KENWOOD

SERVICE BULLETIN

SUBJECT
TM-211/411 AF GAIN CONTROL PART CHANGE
DATE
9-16-85

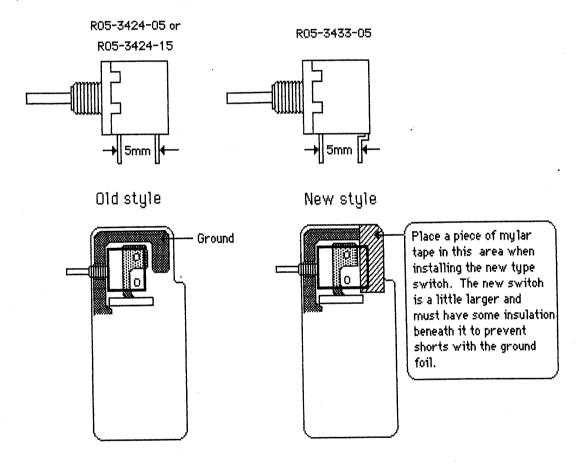
The original AF Gain control (R05-3424-15) has been replaced by a new part, with a new part number. The new part differs in mounting method and appearance. This should cause the operator no problems, and only requires a little change in the mounting method. The diagrams below are self explanitory:
